PLANNING COMMISSION
DATE: 2/23/15
AGENDA ITEM: 5A – BUSINESS ITEM
CASE # 2015-08

ITEM: Lennar Homes Sketch Plan – Diedrich/Rieder Property

Re: Diedrich Property – PUD Concept Plan Review

DIEDRICH PROPERTY – DESIGN REVIEW REPORT **LAKE ELMO, MN**

LANDSCAPE ARCHITECTURAL DESIGN REVIEW DATED FEBRUARY 18TH, 2015
REVIEWED CONCEPT PLAN SET DATED FEBRUARY 6TH, 2015

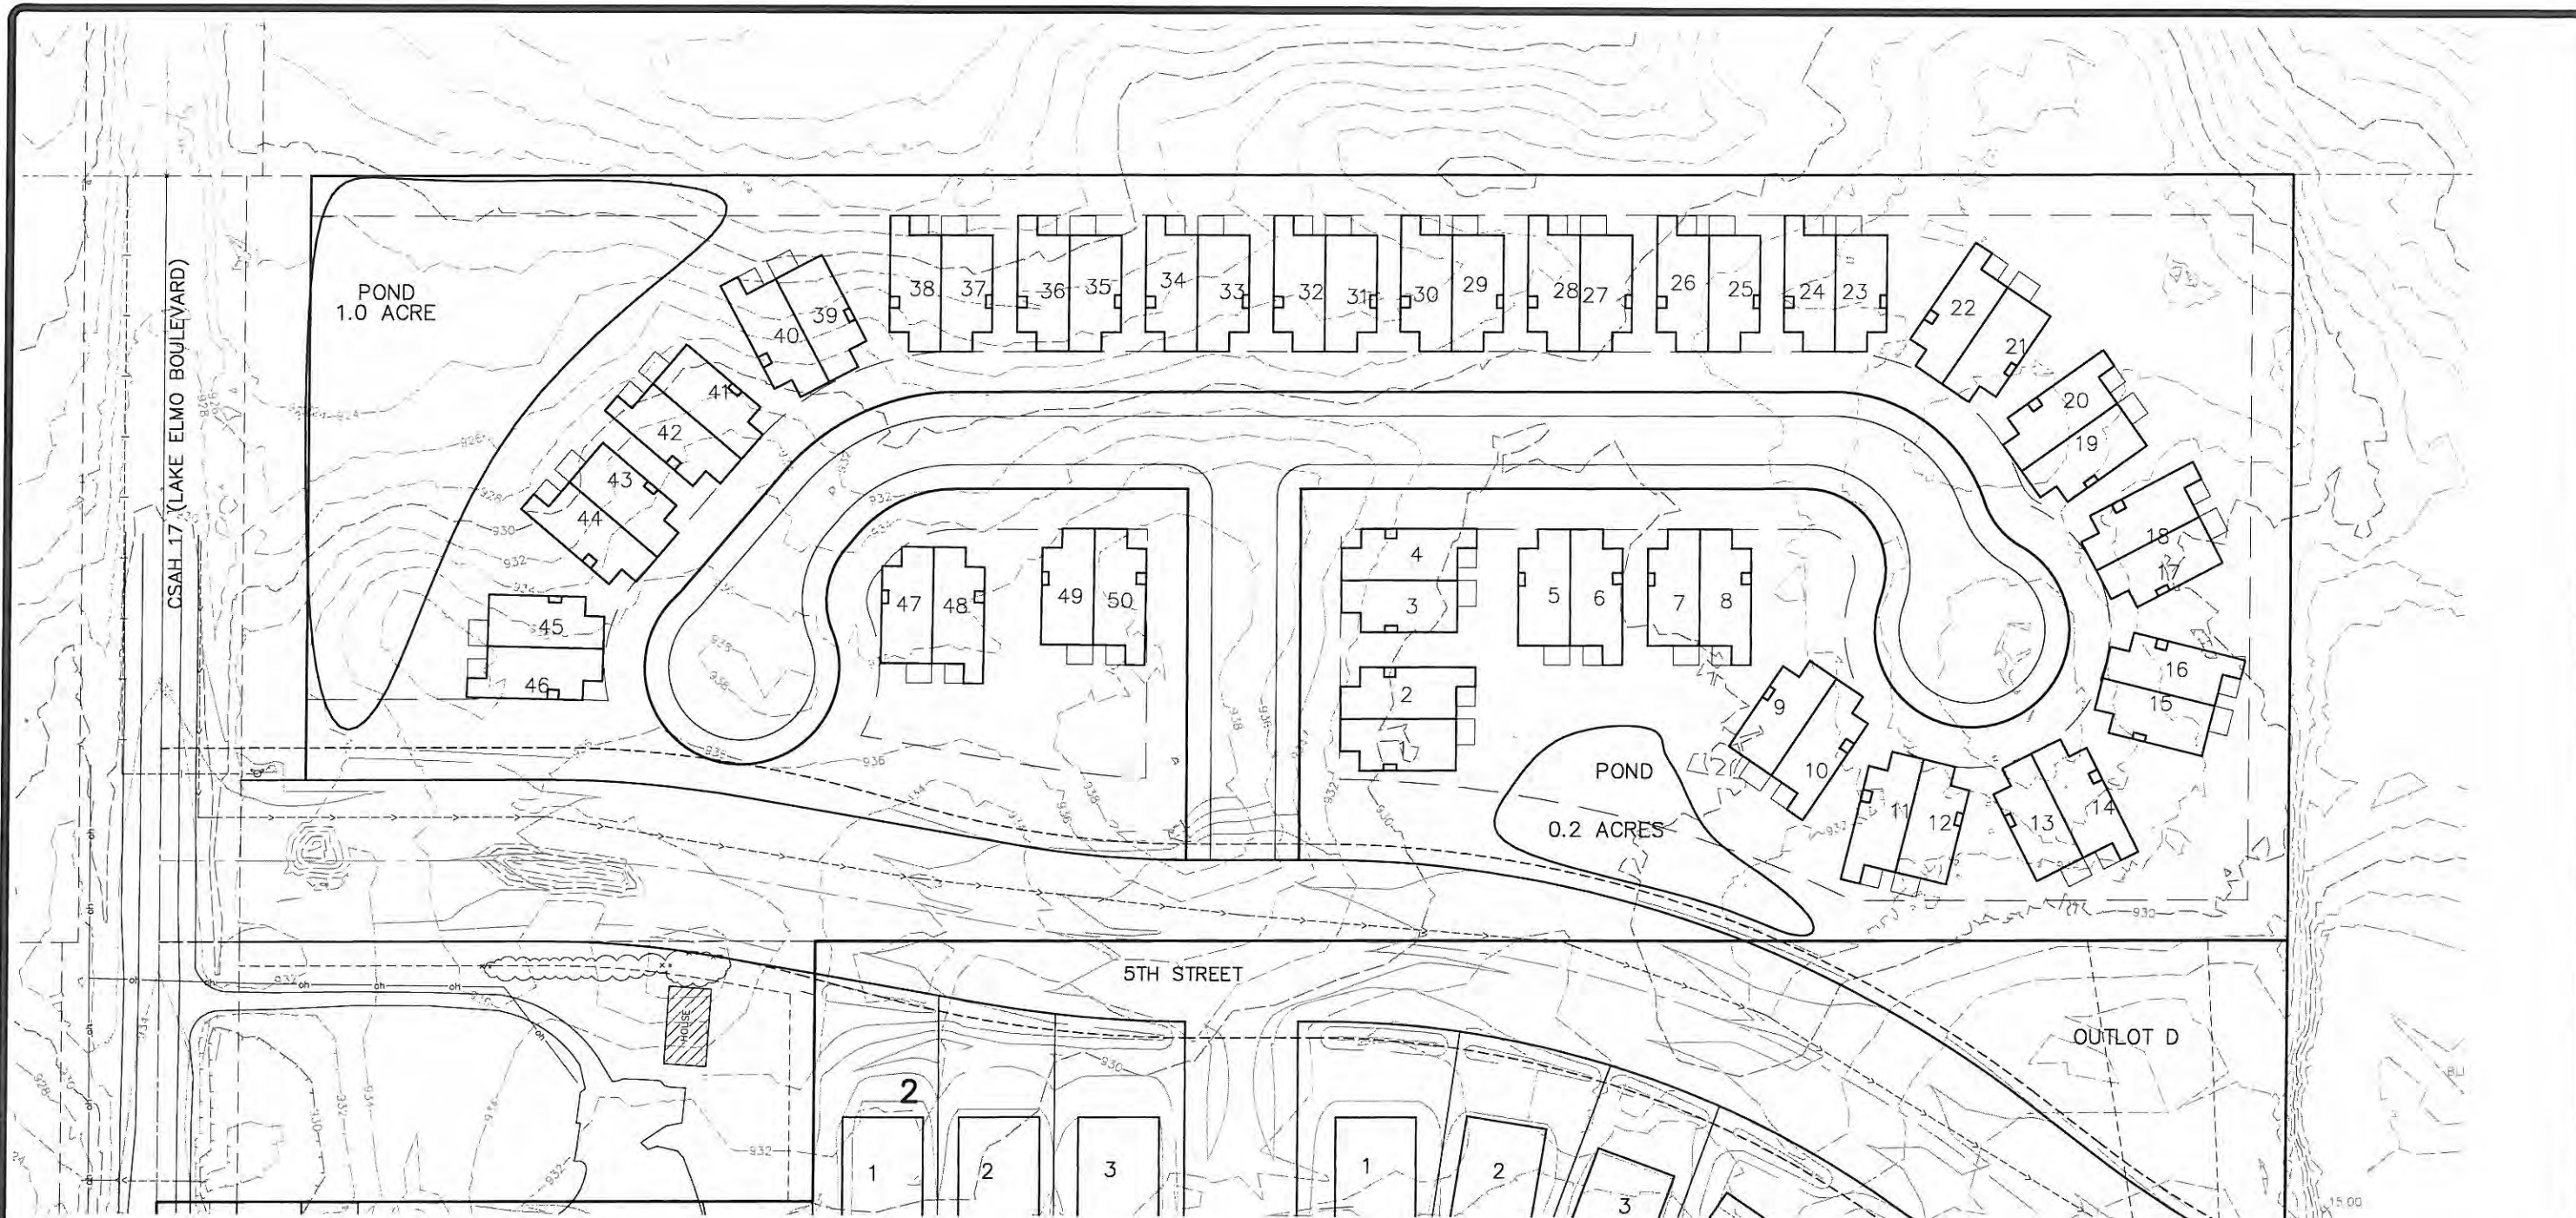
1. Correctly label Lake Elmo Avenue North on the western edge of the property. Currently it is labeled Lake Elmo Boulevard.
2. Since this preliminary site plan doesn't address plantings within this set of plans we are excited to look at the next generation of plan development set which will have that level of specification for our review.

3. We request more information as it relates to the tree preservation plan.
4. Your site layout design should be working with and incorporating natural features of the site especially the existing vegetation.

5. Please provide an analysis of street tree plantings in relationship to proposed residential utility connections and proposed driveways with appropriate setbacks from both utility service connections and driveways. It appears that once this exercise is completed with the current lot widths and proposed home locations there will be little or no room for proposed street trees as currently represented. Therefore, an adjustment of the lot widths and or reducing the number of proposed housing units may need to take place to facilitate the incorporation of the required trees in the streetscape corridor. A minimum of one (1) tree shall be planted for every fifty (50) feet of street frontage.

6. At all property boundaries please provide design sections for all landscape screening suggested representing all typical planting arrangements with species specified and represented to scale at time of installation. When planting berms please consider planting side slopes verses simply planting the top. Plants are much happier when not placed on the highest, driest and windiest part of the berm.

7. Please provide design drawings for development sign, theme & gateway experiences.
